## Change of the anti-tipper on Flexx series

Previous Version	Updated version
<p><b>109mm</b></p>	<p><b>129mm</b></p>

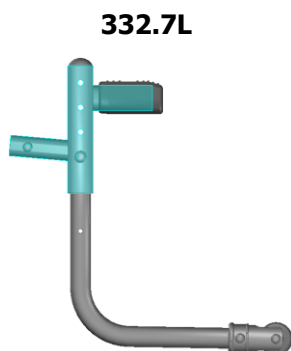
- ✔ In response to the anti-tipper spring accidentally detaching when a user was operating it by foot, Karma has changed the length of the outer tube (note in red) from 109mm to 129mm. Note that this change will NOT affect the total length of the wheelchair.
- ✔ The updated version is backward compatible with the existing one.
- ✔ The updated version was implemented by the batch of serial no. TM22-074041.
- ✔ The updated version was implemented on Flexx series.
